Responses from FAA - Neighbor Meeting with FAA and Airport Management and Neighborhood Follow Up Questions:**Question #1 to FAA:**

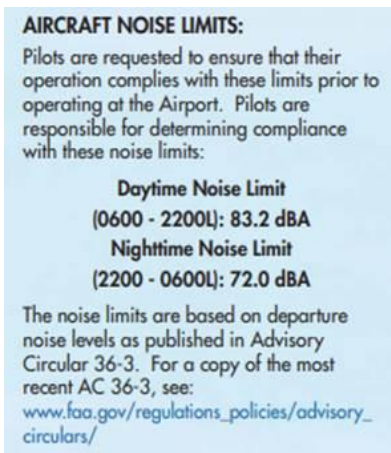
Readings of 89 decibels are an everyday occurrence in our neighborhood while the STS airport itself lists 83.2 decibels as its daytime noise level limit. See image below from the STS airport website. Please explain.

Figure 3.10-1
2009 CNEL CONTOURS

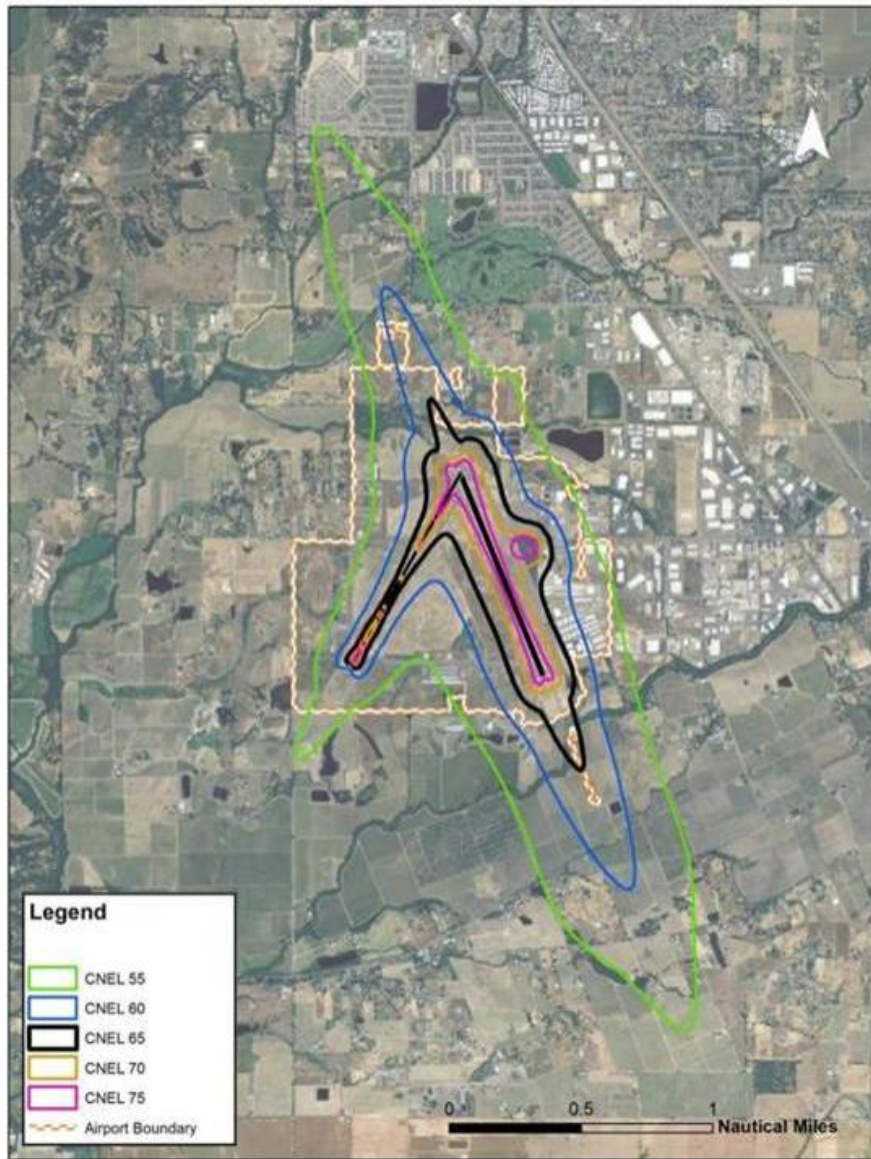
So, 2.5 miles from the airport (Wellington Circle) is in the landing zone and not in the ambient noise zone? Why is this not shown on the Airport Noise Map below? (Vintana is on the northern edge of the green CNEL 55. Wellington Circle is off this map to the north.) Please give us the updated noise contour map as this one is from 2009, especially showing the 89+ decibel readings in the Wellington Circle area.

The sources of the figure above is unclear. It is the airport sponsor's role to pursue noise related studies and determine noise impacts from the airport.
